CORRIGENDUM 1

Figure 1

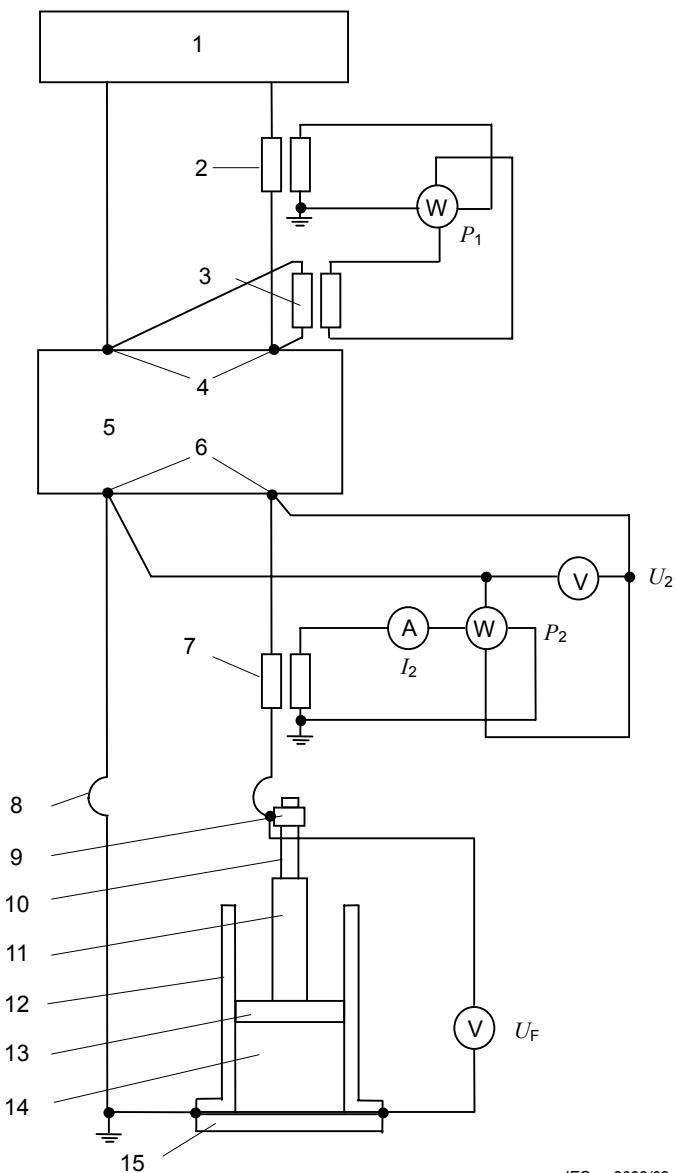
Remplacer la Figure 1 existante par la nouvelle Figure 1 suivante (dans laquelle un symbole de mise à la terre a été ajouté au circuit de puissance).

Replace the existing Figure 1 by the following new Figure 1 (in which an earthing symbol has been added at the power circuit).

Figure 2

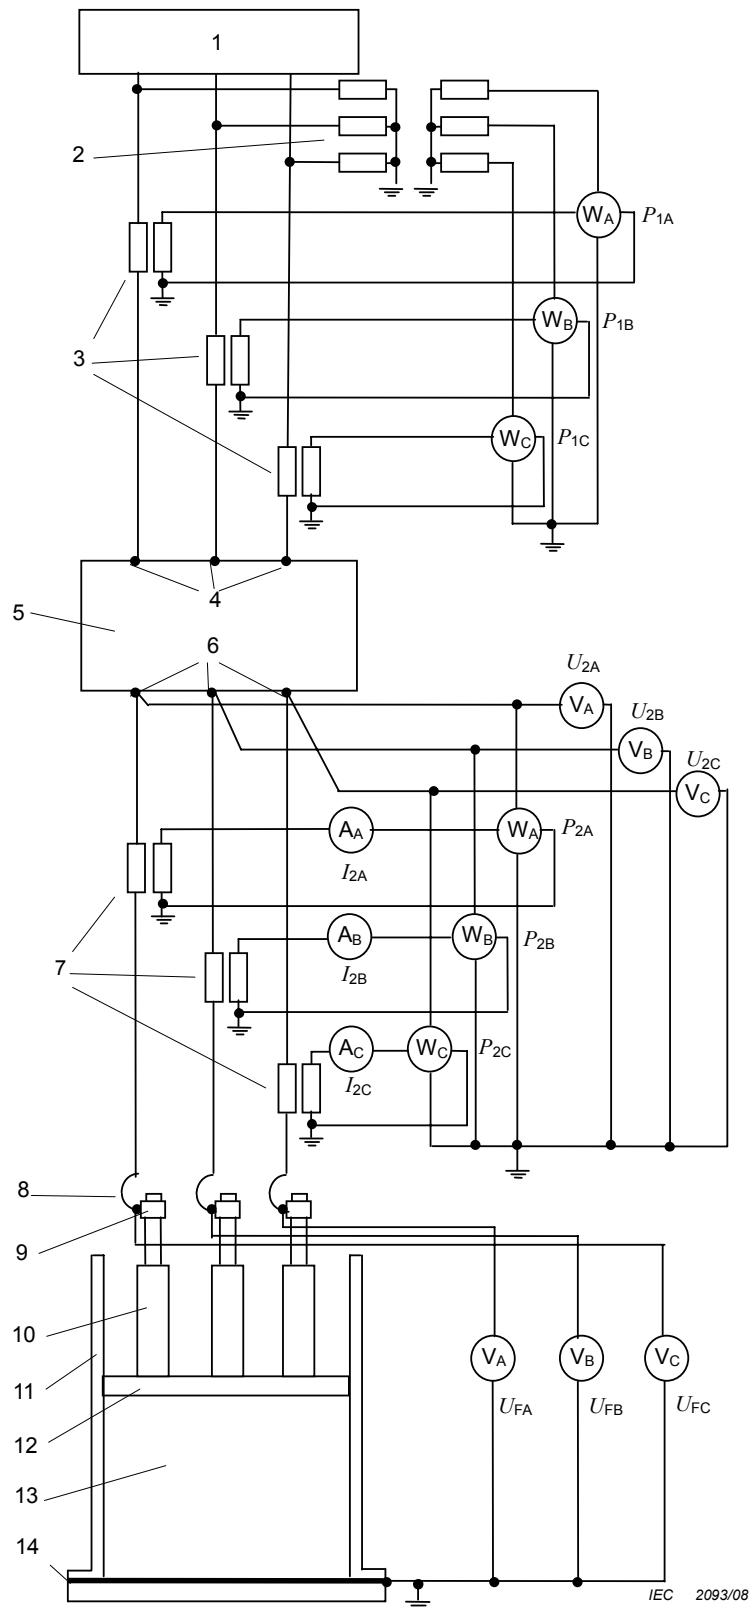
Remplacer la Figure 2 existante par la nouvelle Figure 2 suivante (dans laquelle un symbole de mise à la terre a été ajouté au circuit de puissance).

Replace the existing Figure 2 by the following new Figure 2 (in which an earthing symbol has been added at the power circuit).

Figure 3

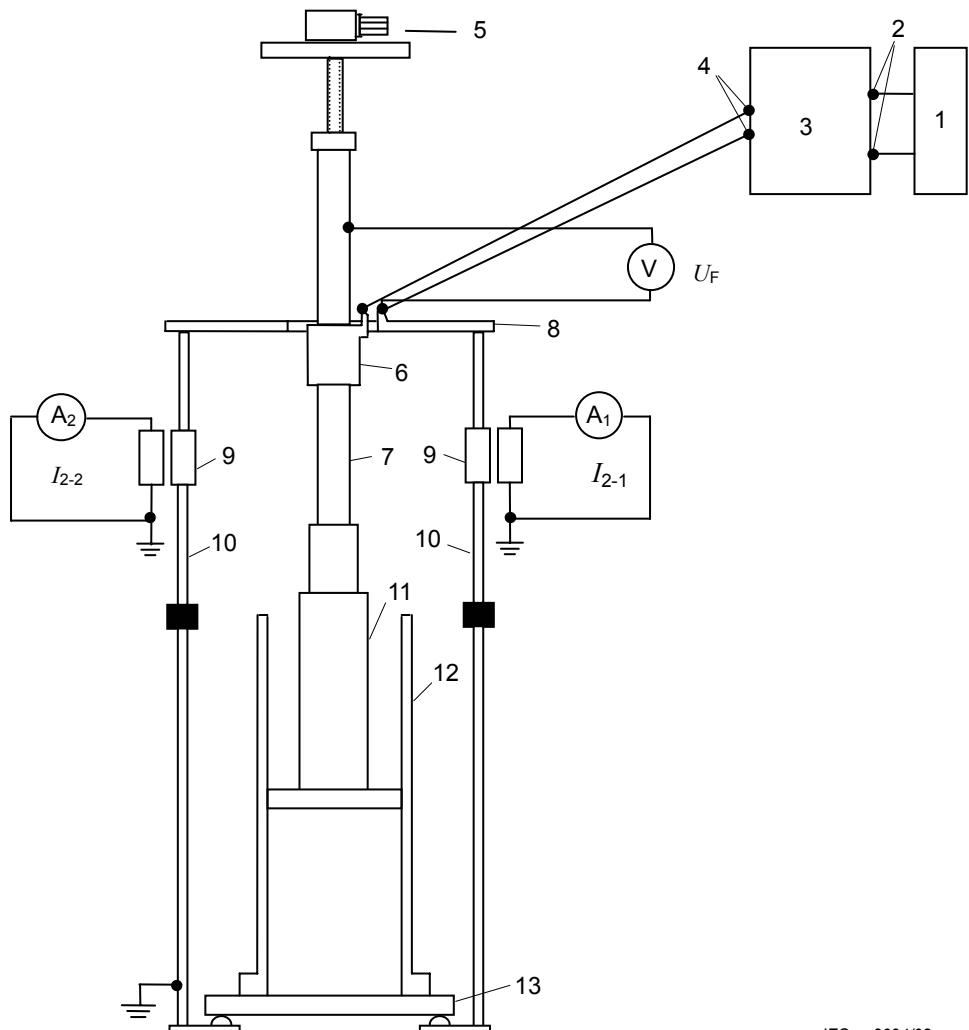
Remplacer la Figure 3 existante par la nouvelle Figure 3 suivante (dans laquelle un symbole de mise à la terre a été ajouté au circuit de puissance).

Replace the existing Figure 3 by the following new Figure 3 (in which an earthing symbol has been added at the power circuit).
